Access Compliance Report

Public Rights-of-Way

Intersection ID: 29677	Main Street: CAMERON_CREEK_DR	Cross Street: HUNTINGTON_RIDGE_CT	Location: NE
ADA ID: 2F726C96BA8B	Ramp Type: PerpDiag	Initial Pass/Fail: Fail	Overall Compliance: No
		Severity Score: 10

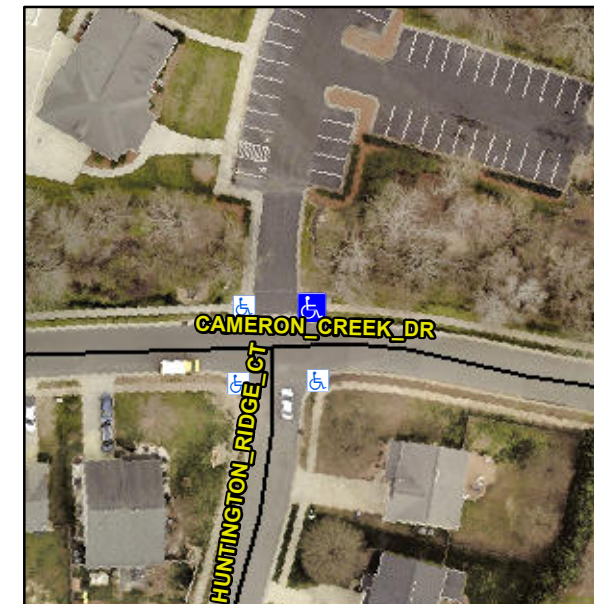
Not Found, R304.5.1, R304.5.3

Compliance	Description	Data	Compliance	Description	Data
N/A	Ramp Length (in)	51.0	Yes	Ramp Slope (%)	8.0
No	Ramp Width (in)	42.0	No	Ramp XSlope (%)	3.5
N/A	Flare Type LT	N/A	N/A	Flare Type RT	N/A
N/A	Flare Slope LT (%)	N/A	N/A	Flare Slope RT (%)	N/A
N/A	Flare Traversable LT?	N/A	N/A	Flare Traversable RT?	N/A
N/A	Landing Length (in)	N/A	N/A	DWS Provided?	N/A
N/A	Landing Width (in)	N/A	N/A	DWS Contrast?	N/A
N/A	Landing Slope (%)	N/A	N/A	DWS Length (in)	N/A
N/A	Landing X Slope (%)	N/A	N/A	DWS Full Width?	N/A
N/A	Landing Curb? (Y/N)	N/A	N/A	DWS Offset (in)	N/A
N/A	Shared Landing?	N/A			
N/A	Gutter Ponding?	N/A	N/A	Gutter Slope (%)	N/A
N/A	Gutter Lip Ht (in)	N/A	N/A	Gutter X Slope (%)	N/A
N/A	Painted X Walk1?	No	N/A	Painted X Walk2?	No
	X Walk 1 Direction	To W		X Walk 2 Direction	To S
N/A	X Walk 1 Width (in)	N/A	N/A	X Walk 2 Width (in)	N/A
	X Walk 1 Slope (%)	0.3		X Walk 2 Slope (%)	2.4
	X Walk 1 X Slope (%)	3.7		X Walk 2 X Slope (%)	1.3

Remove & Replace Curb Ramp With Two New Directional Ramps or Equivalent.
